Appendix I of RNTPC
Paper No. A/YL-TYST/1334A

**APPLICATION FOR PERMISSION
UNDER SECTION 16 OF
THE TOWN PLANNING ORDINANCE
(CAP. 131)**

(a) Proposed use(s)/development 擬議用途/發展
 Temporary Open Storage of Construction Machinery and Construction Materials, Recycling Materials and Used Electrical Appliances with Ancillary Workshop for a Period of 3 Years
 (Please illustrate the details of the proposal on a layout plan) (請用平面圖說明擬議詳情)

The proposed use is under S.16 planning application with case no. A/YL-TYST/1334. This DIA report is prepared in support of the planning application.

Title:
 Drainage Proposal - LAYOUT

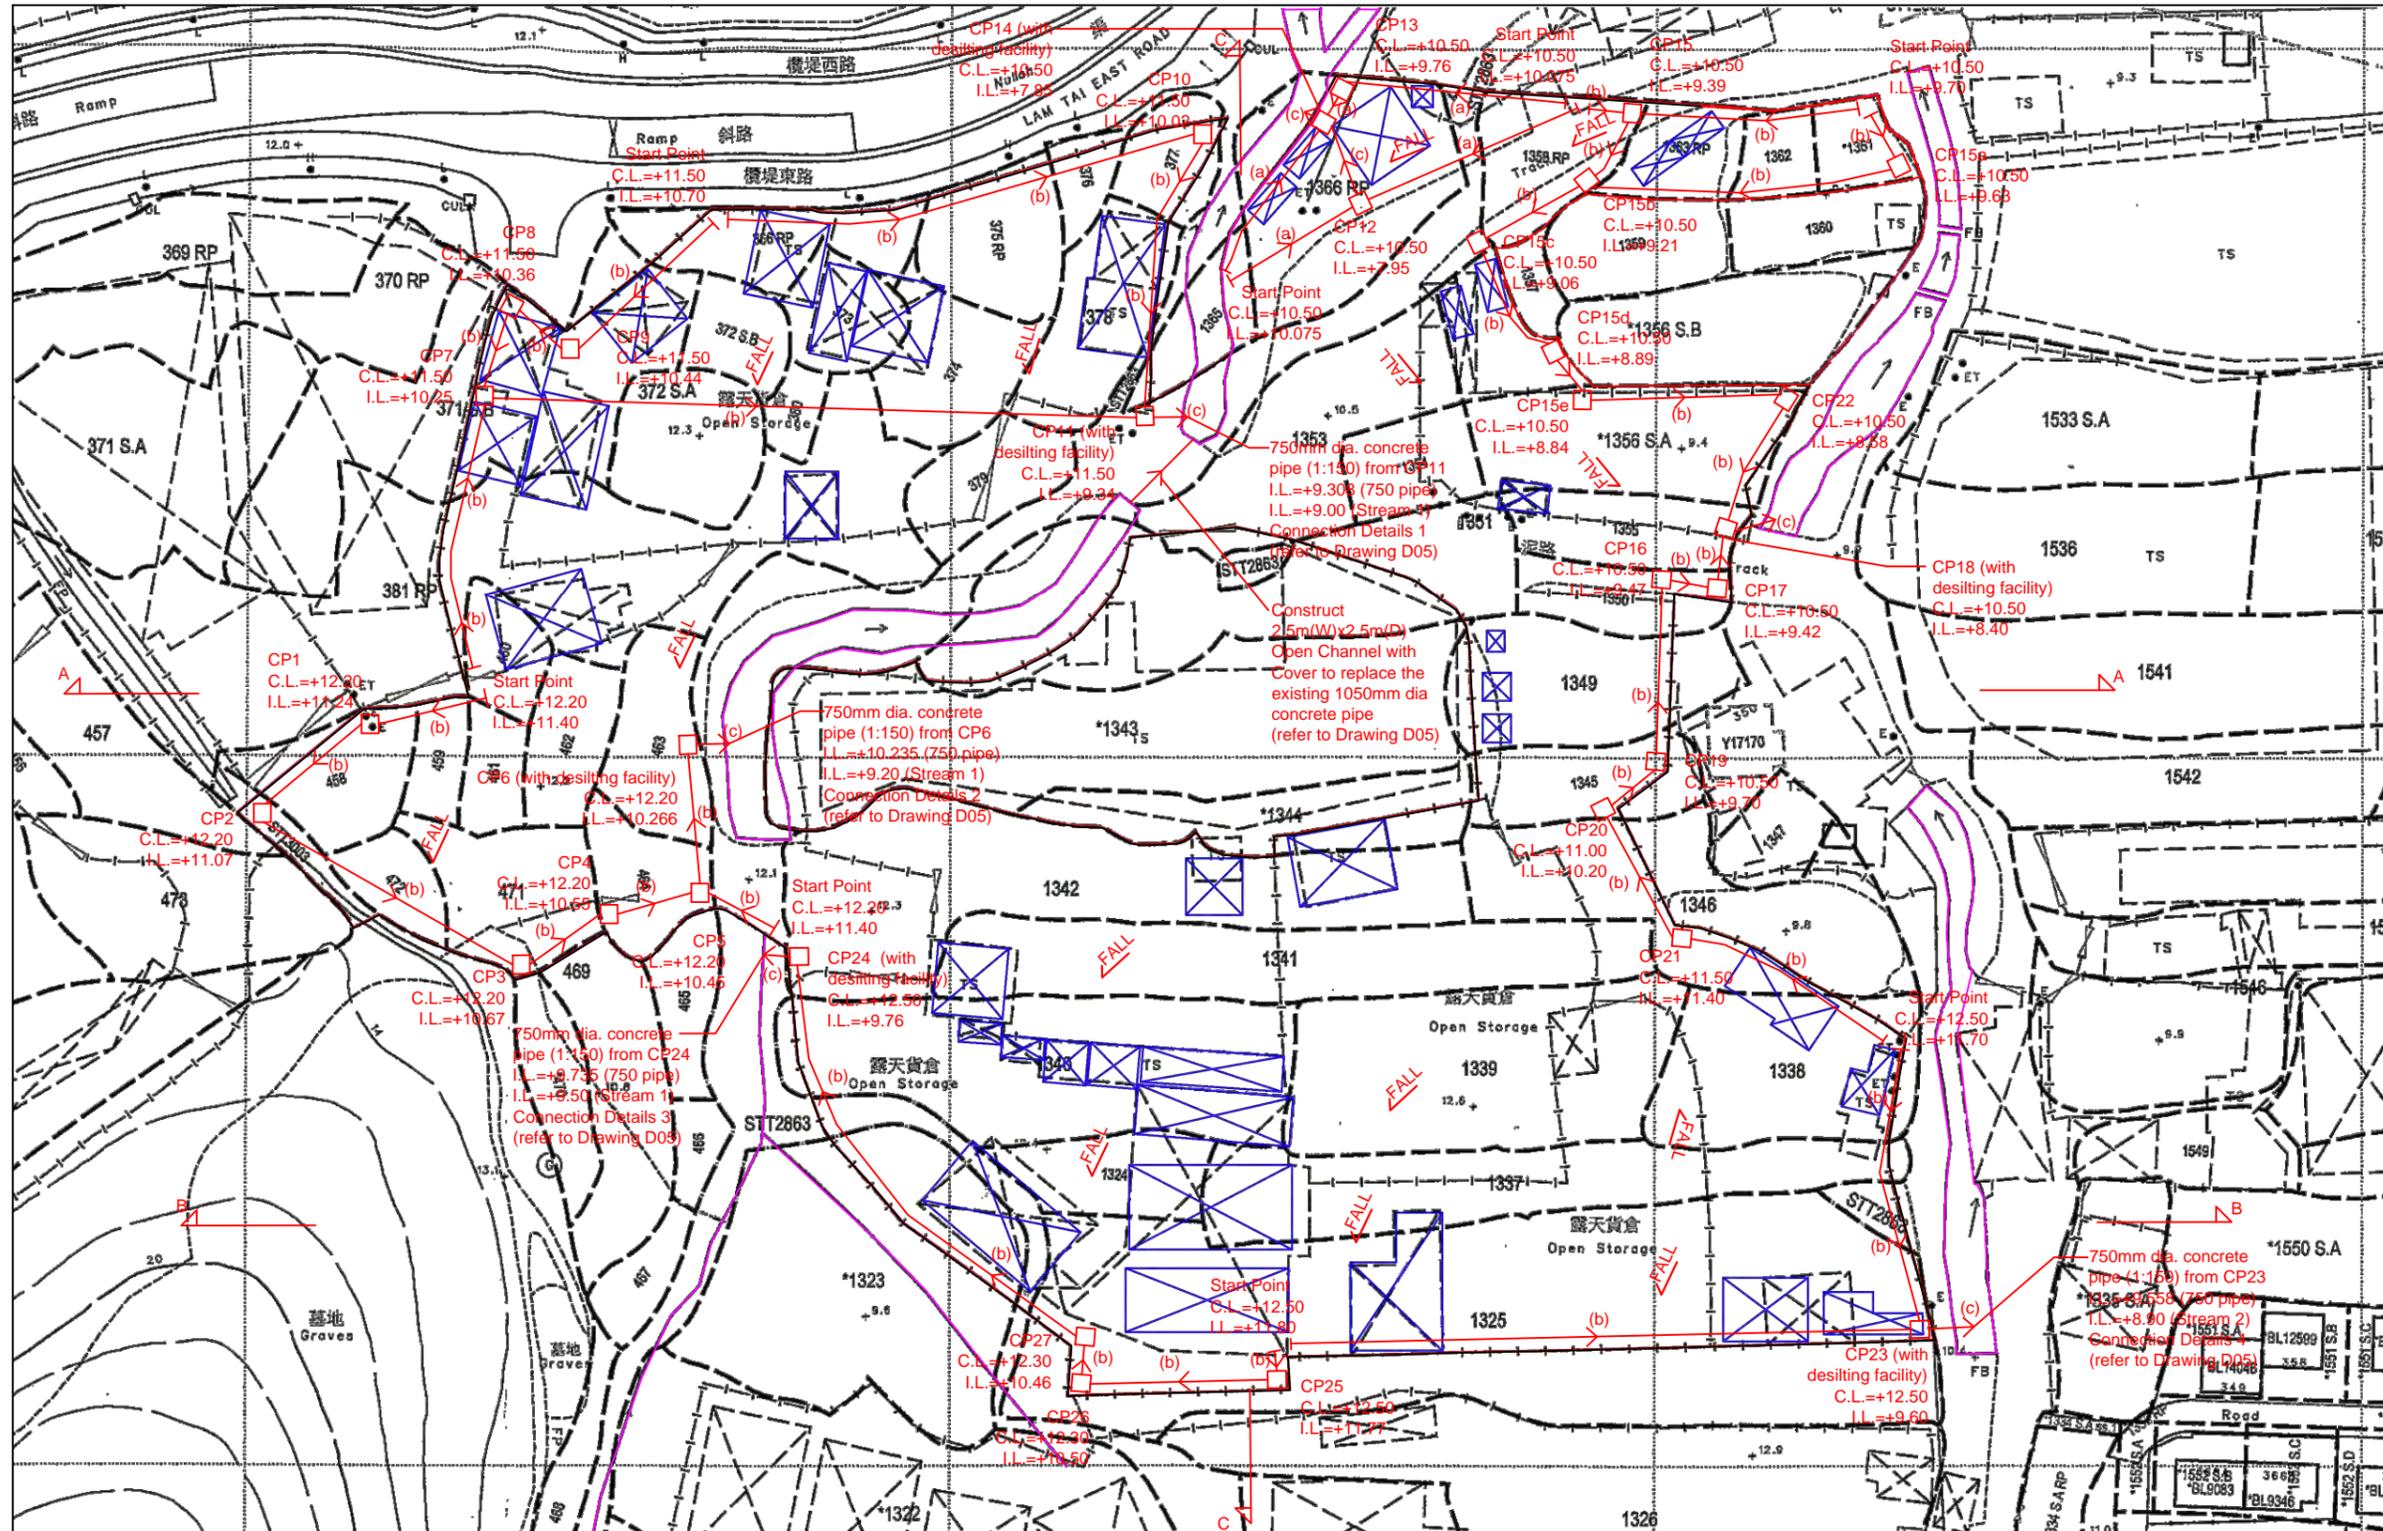
- Please indicate the gradient and invert level of the outlet pipe at Stream 1 & 2. Please also indicate the invert level of the stream bed level at the discharge point and provide details/section of the discharge pipe to the stream. **It is indicated in Drawing D01 and D05**

- The invert level of CP6 (+10.53mPD) should not be higher than the invert level of upstream CP5 (+10.45mPD), please review. **It is revised accordingly.**

Title:
 Drainage Proposal - Catchment Area Plan

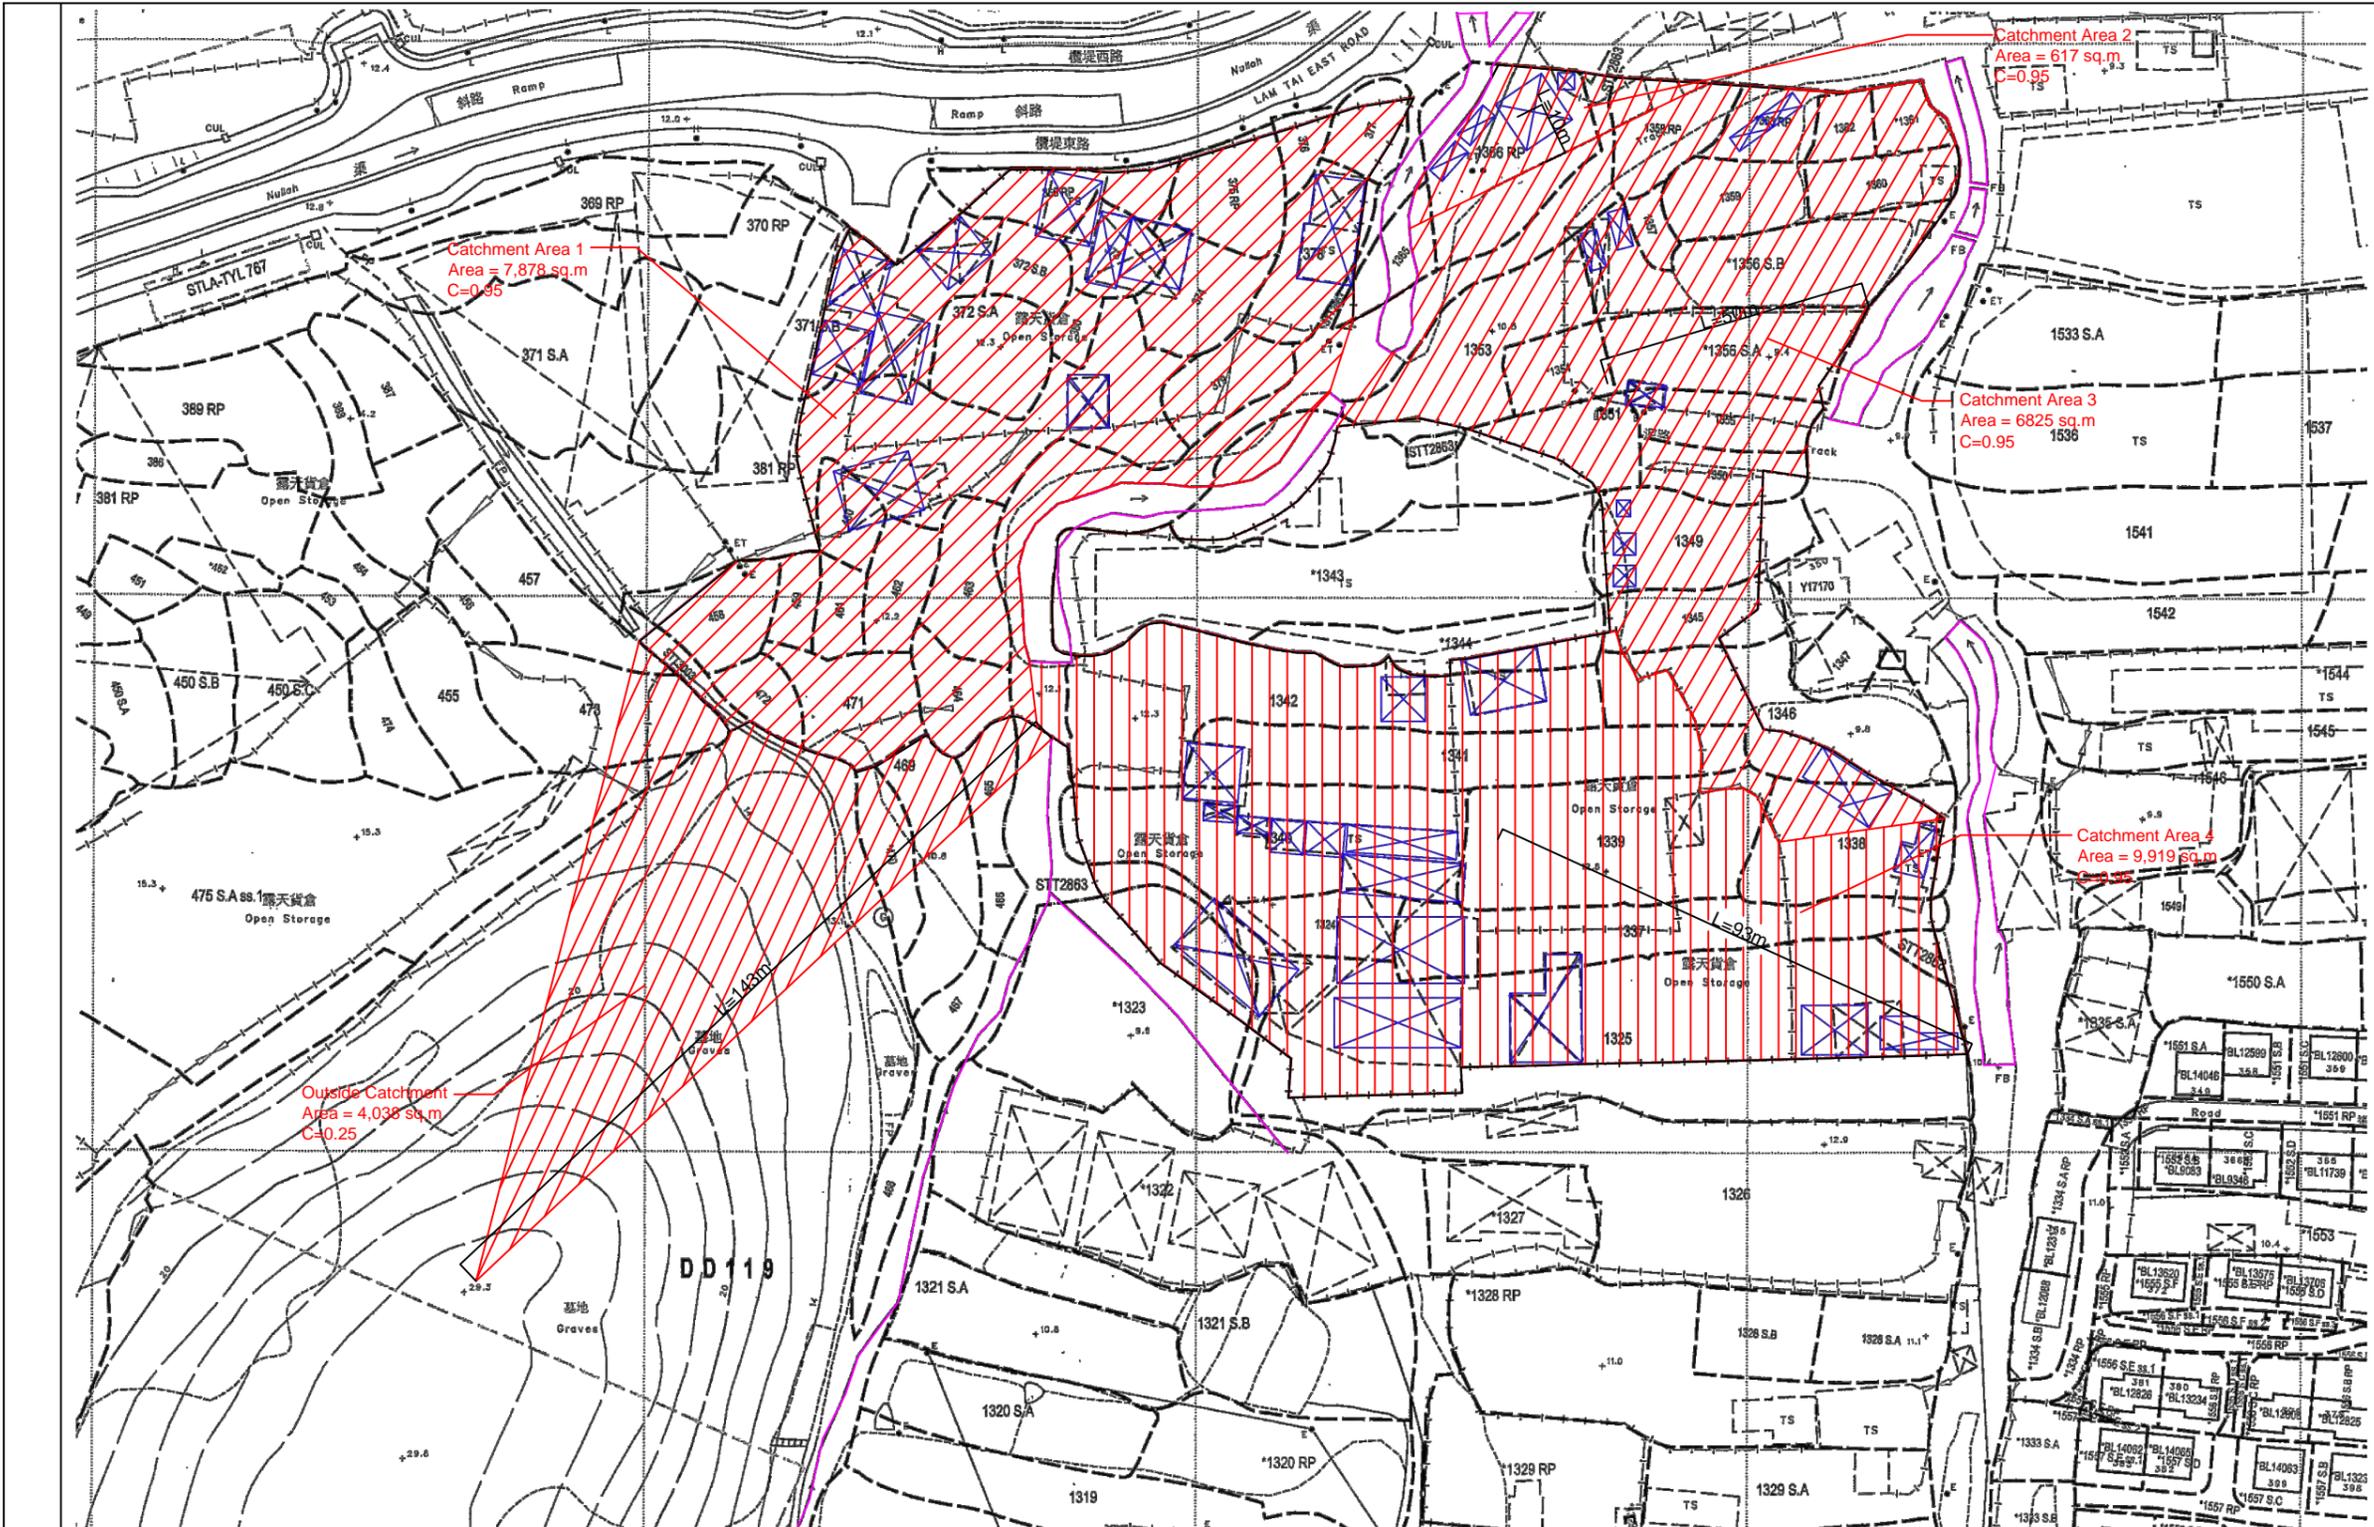
- Please clarify why Lot Nos. 1356 S.B, 1357, 1359 & 1360 which are within your application site as shown in Appendices A & B are excluded from the catchment area plan. **These catchment areas have been considered.**

- Please review the H value which should be the average slope (m per 100m), measured along the line of natural flow, from the summit of the catchment to the point under consideration (i.e. $\delta h / L \times 100$), instead of 1. **Revised accordingly.**
- Please review if the existing nullah beside Lam Tai East Road should be considered as a main rural catchment drainage channel and adopt 50 years design return period. **Revised accordingly.**

Figure 4

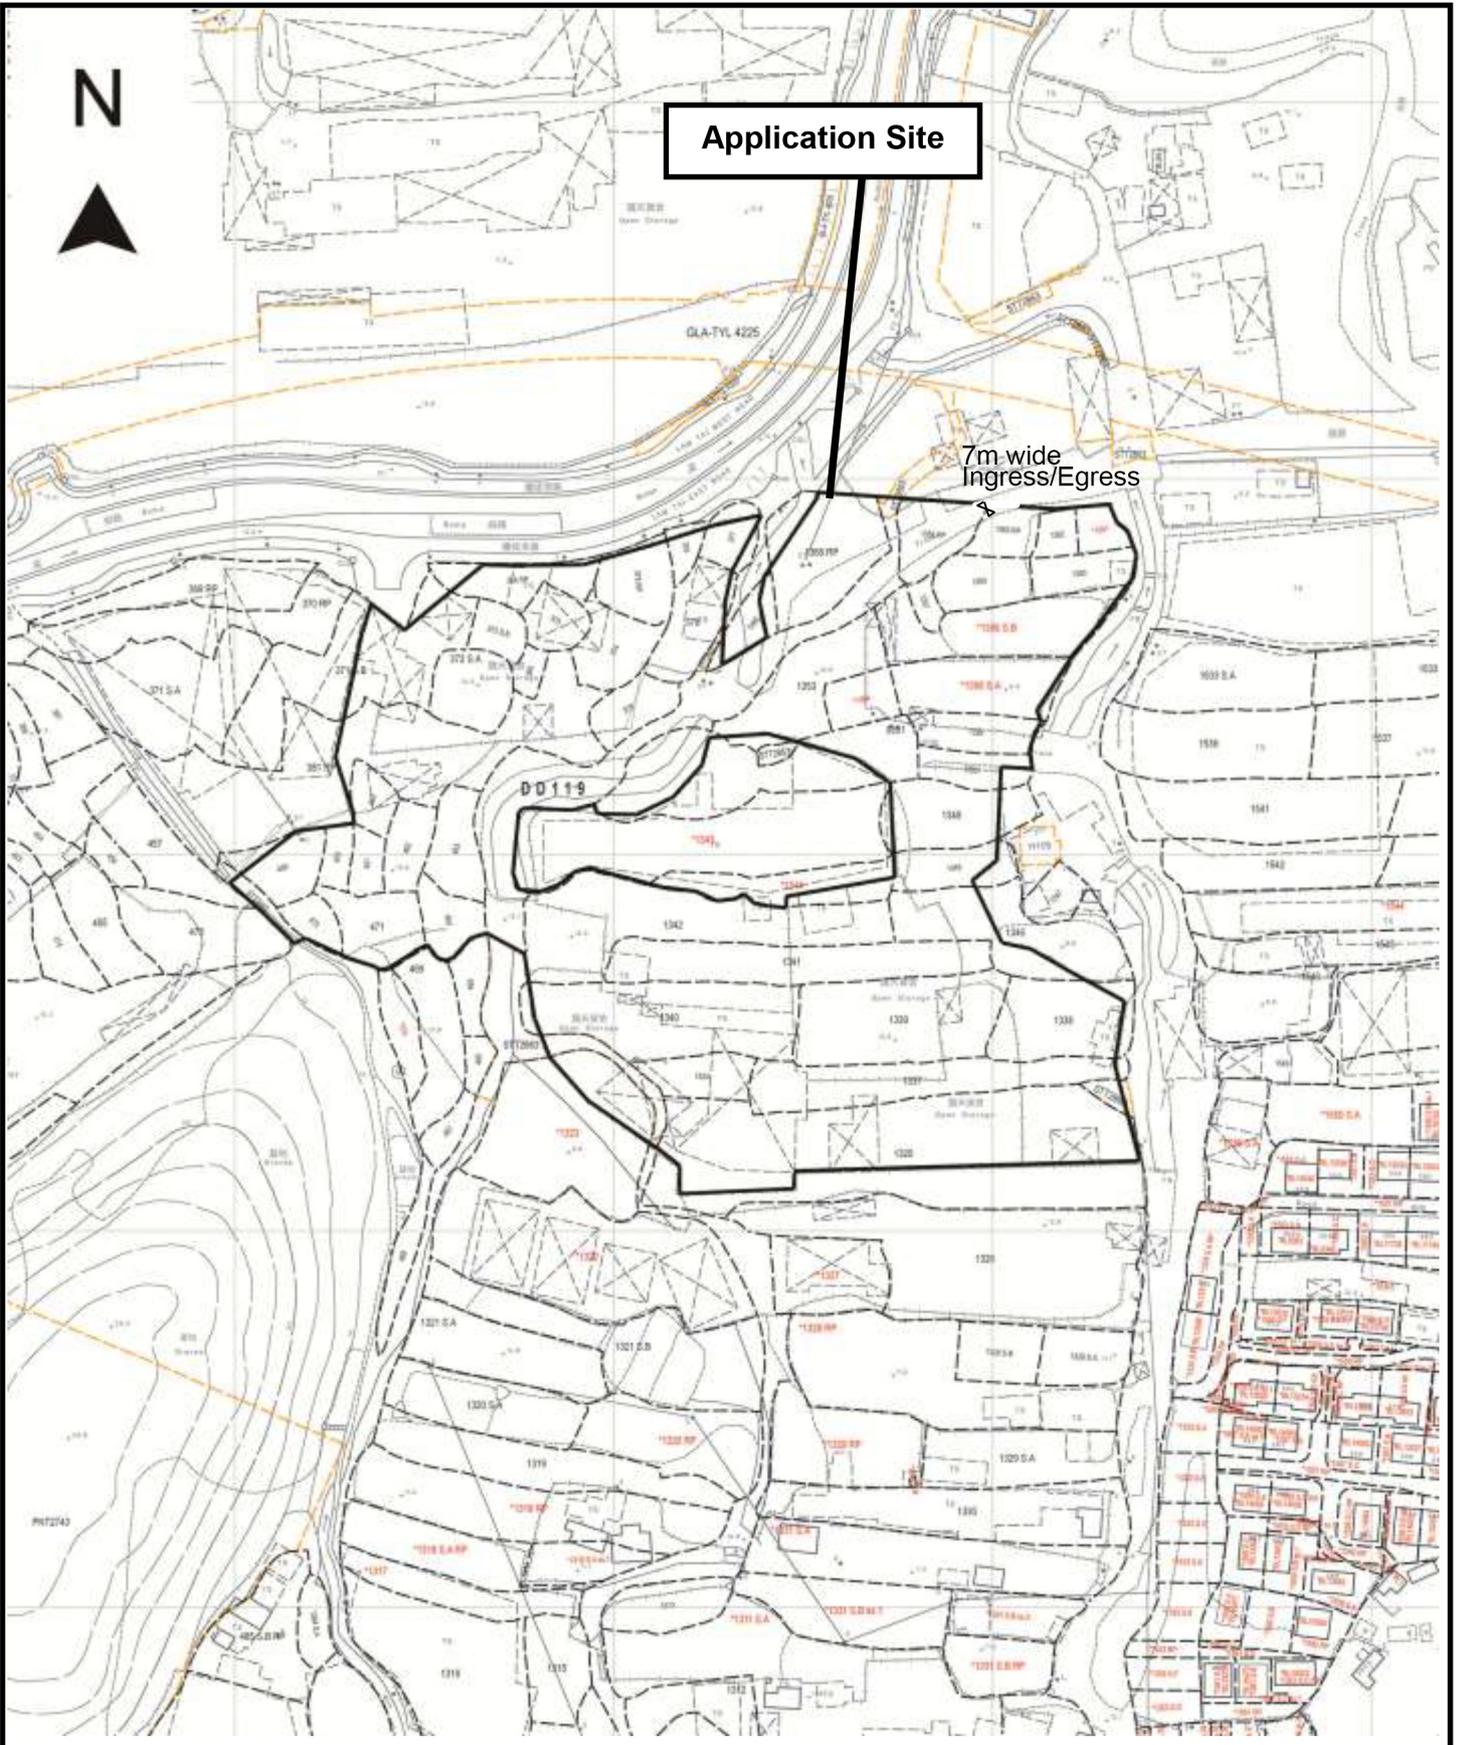
Transport Department's comments	Applicant's response
(a) Would you please ask the applicant's to indicate the vehicular run-in/out and dimension of it on its layout plan for my further consideration.	Noted. Please see attached Figure 4.
